Attachment 2 Apartment Design Guideline

Criteria/Guidelines	Comments
Part 2 Development the Controls	
<p>2E Building Depth</p> <p>Use a range of appropriate maximum apartment depths of 12-18m from glass line to glass line. This will ensure that apartments receive adequate daylight and natural ventilation and optimise natural cross ventilation.</p>	<p><u>Building 1</u> Ground floor to Levels 2 - The building depth ranges from 16m to 19.5m. This is for the commercial/retail levels.</p> <p>On Level 3 the building depth is 18m. On Levels 4 and above – building depth is 20.</p> <p>The building exceeds the maximum depth, ranging from 19.5m to 20m. The proposal is for a concept approval only so the unit mix and layout are indicative only. Notwithstanding this, the proposal has indicated that an acceptable levels of cross ventilation and solar access can be achieve. Condition 10 has been imposed requiring compliance with the requirements of the ADG.</p> <p><u>Building 2</u></p> <p>Ground floor - The building depth ranges from 14m to 37m. This is for the commercial/retail levels. On Levels 2 & 3 the building depth ranges up to 55m. These larger depths are to fit future commercial uses and

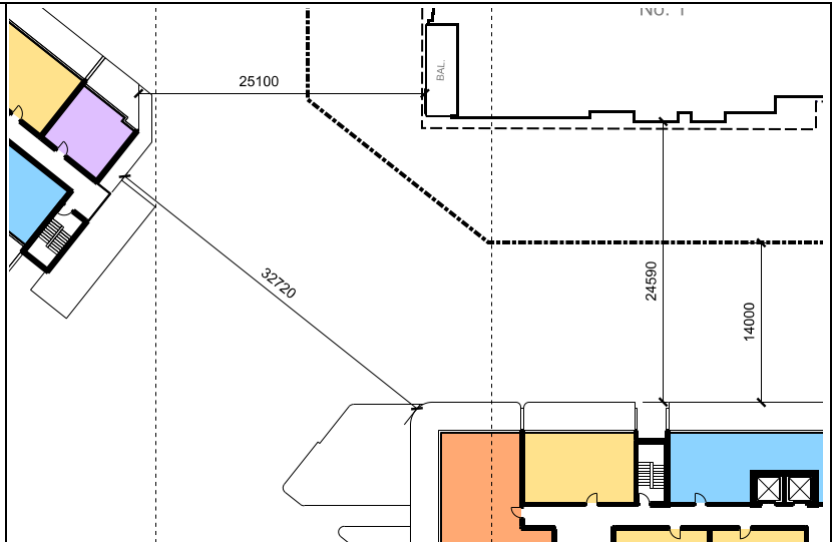
L8-11 of Building 1 and L8-9 of Building 2 – minimum separation of 24m

L4L12-13 of Building 1 and L10-11 of Building 2 – separation of 32.7m on the topmost levels.

The proposal complies with the ADG separation requirements between Buildings 1 & 2 and 1 Saunders Close.

Ground floor plan of Buildings 3, 4, & 5 – minimum separation of 21m for Ground floor to L12.

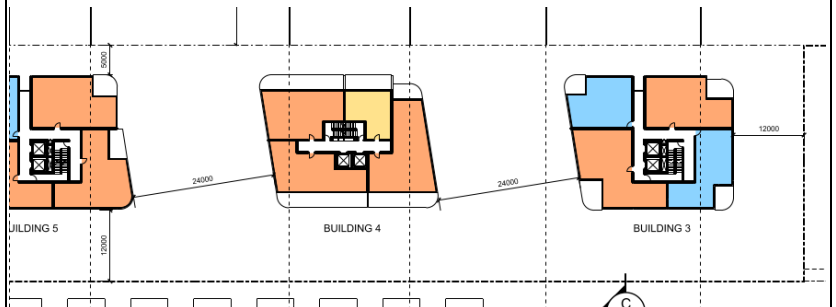
L13 to 14 – 24m separation.
